CPED STAFF REPORT

CPC Agenda Item #6
November 10, 2014
BZZ-6898

Property Location: 516 8th Street South

Project Name: Portland Tower

3 WEST ELEVATION
ALLEY SCALE: 1" = 10'-0"

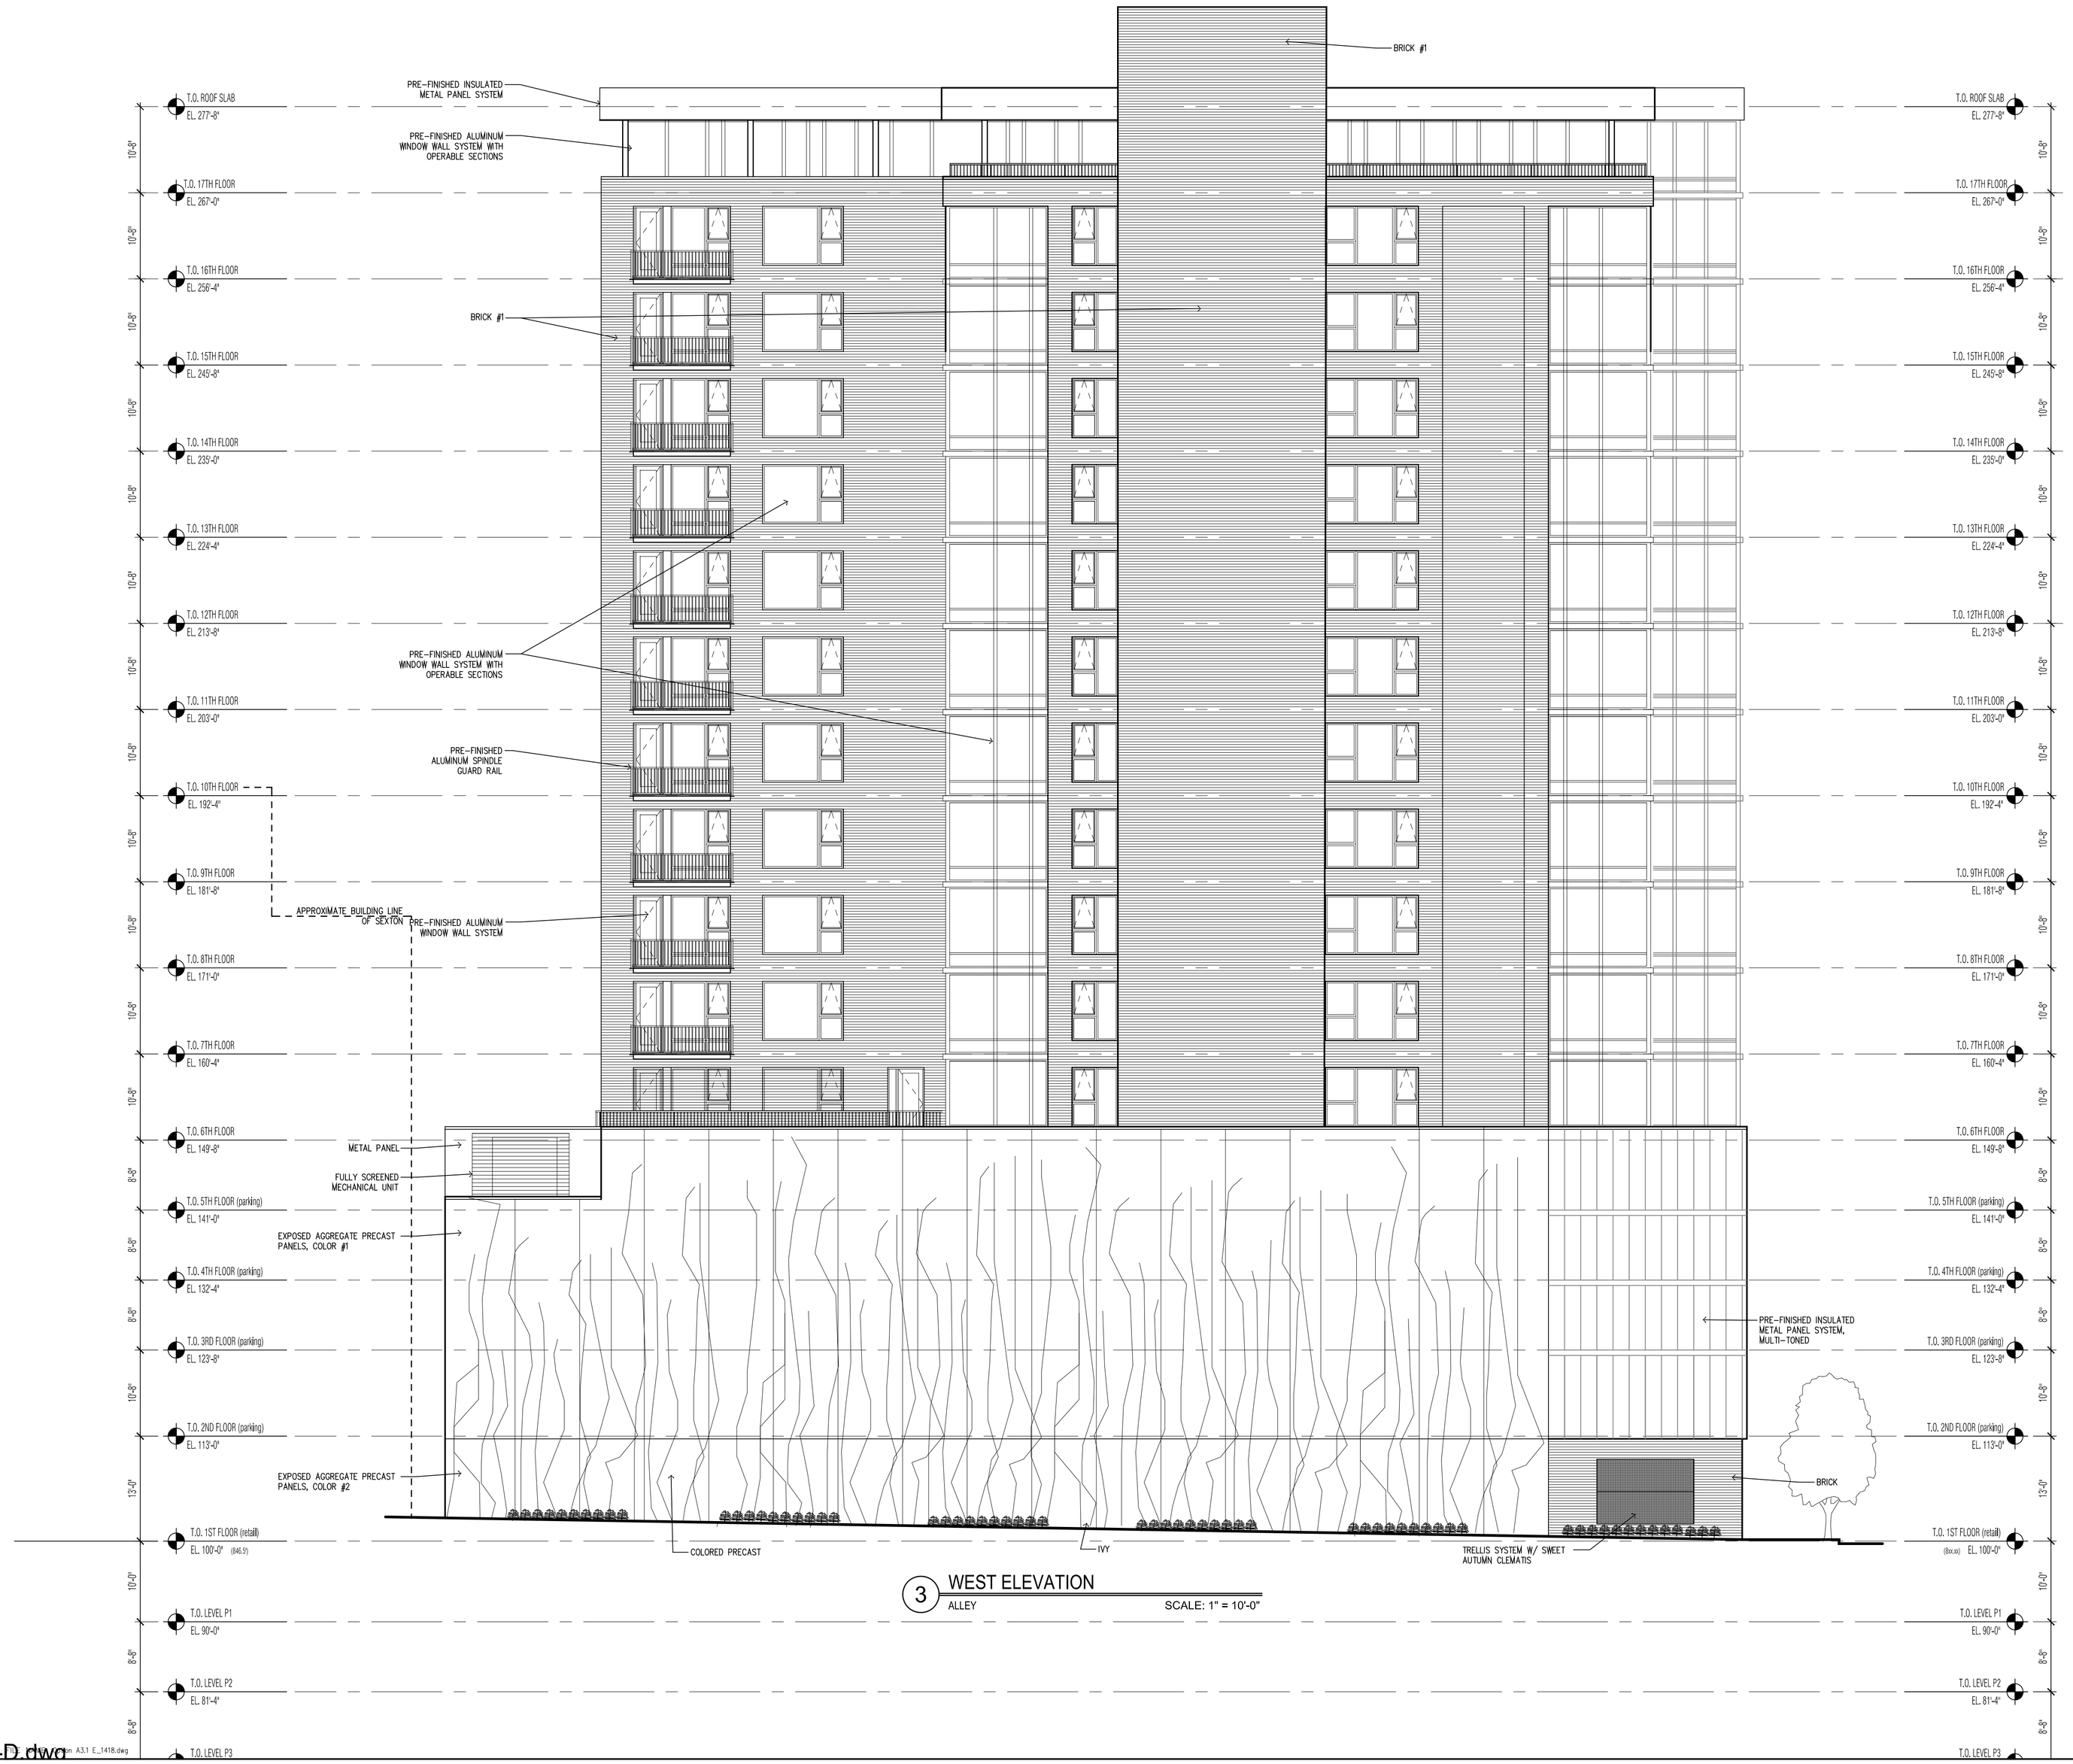
a. ***Interior side yard setback along the west property line:*** The applicant proposes to reduce the interior side yard setback from 15 feet to 11 feet along the west property line. In the downtown districts, residential uses facing an interior side yard are required to provide

a. ***Interior side yard setback along the west property line:*** The proposal to reduce the interior side yard setback along the west property line from 15 feet to 11 feet is reasonable and would be in keeping with the spirit and intent of the ordinance and the comprehensive plan. As previously noted, there is no setback that applies until the 6th floor of the building as a result of the residential uses. The abutting property to the west is occupied by the

House of Charity and their building is located approximately 12 feet, 8 inches from the property line, providing a separation of approximately 22 feet, 8 inches between the residential floors of the proposed building and the existing adjacent building. Increasing the setback 5 additional feet would not provide any additional relief to the adjacent property as the setback would not apply until the 6th floor of the proposed development, or above the roofline of the adjacent building. The request is reasonable and contextually appropriate in this specific circumstance. Further, if the property to the west is developed with a structure built up to the shared property line, the proposed setback ensures that light and air to these dwelling units would be sufficiently preserved.

- There are blank uninterrupted walls greater than 25 feet in length on floors 1-5 of the interior north and west elevations of the building that do not include windows, entries, recesses or projections, or other architectural elements. Alternative compliance is necessary. The applicant is proposing to utilize precast concrete panels on these elevations and plant vines at the base of the building to break up the blank walls. Staff would recommend that the Planning Commission grant alternative compliance for this provision provided green screens are installed and spaced at a distance of no greater than 25 linear feet. Green screens would provide a better growing medium and ensure a denser vertical and horizontal growth of the living wall as opposed to relying on vines planted at the base of the building. Further, Staff would recommend that a portion of the plantings provide greenery year round.

The residential wall with windows along the west elevation (House of Charity) is 11'-0" back from the property line in lieu of the 10' previously stated. This dimension is still less than the 15' required by the zoning code, but just wanted to clarify.

4 NORTH ELEVATION

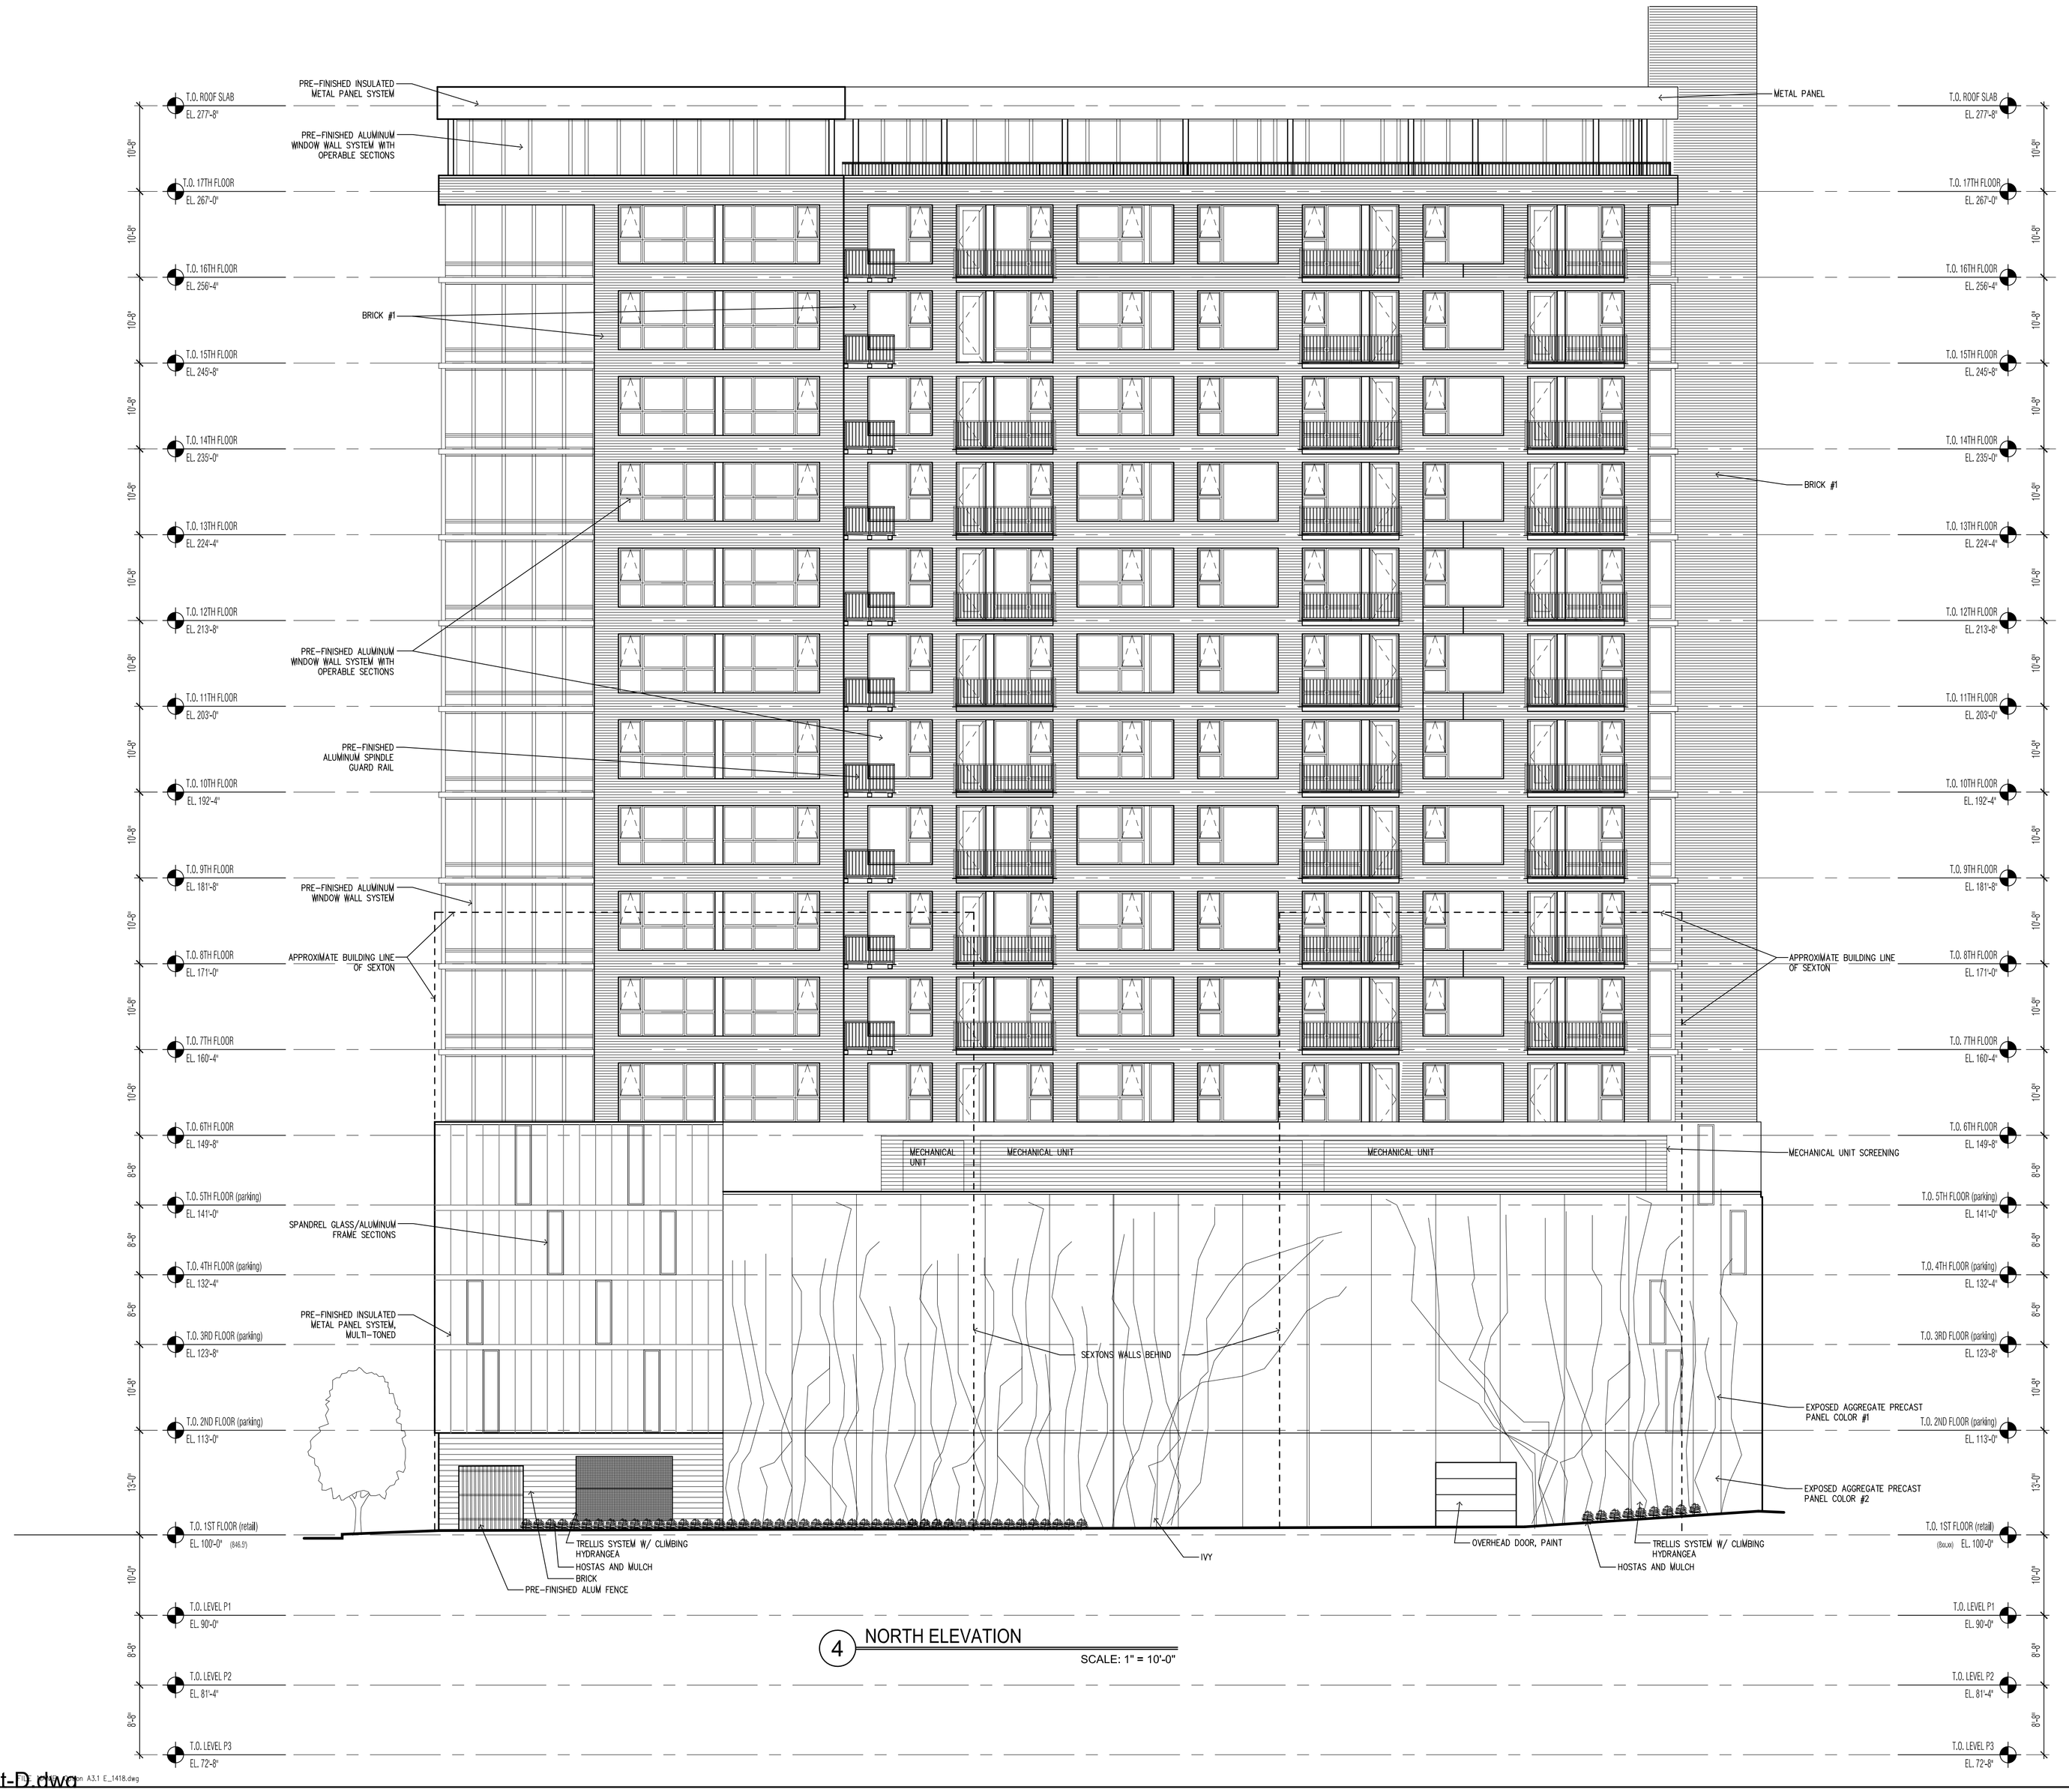
- The exterior materials proposed on the building include brick, metal panels, pre-cast concrete panels, glass and various architectural details. All proposed materials are durable. Pre-cast concrete panels are proposed on the north and west elevations of the building, floors 1-5. Pre-cast concrete panels are not proposed on any of the other elevations and therefore, are not compatible on all sides of the building. Alternative compliance would be necessary. Staff would recommend that the Planning Commission require that the metal panel proposed on the street facing elevations on these floors be installed in lieu of the proposed concrete panels along the north and west elevations of the building in order to maintain material consistency given the visibility of these elevations. Future changes in exterior materials may require review before the

1. CPED Staff review and approval of the final site, elevation, lighting and landscaping plans before building permits may be issued.
2. All site improvements shall be completed by November 10, 2016, unless extended by the Zoning Administrator, or the permit may be revoked for non-compliance.
3. All ground-level windows must be transparent (non-reflective) as required by Section 530.120 of the Zoning Code.
4. Metal panels consistent with those proposed on the street-facing elevations shall be installed on the north and west elevations of the proposed building, floors 1-5, in lieu of the pre-cast concrete panels.
5. Green screens shall be installed and spaced at a distance of no greater than 25 linear feet on the blank walls that exist on the north and west elevations of the building. A portion of the plantings shall provide greenery year round.
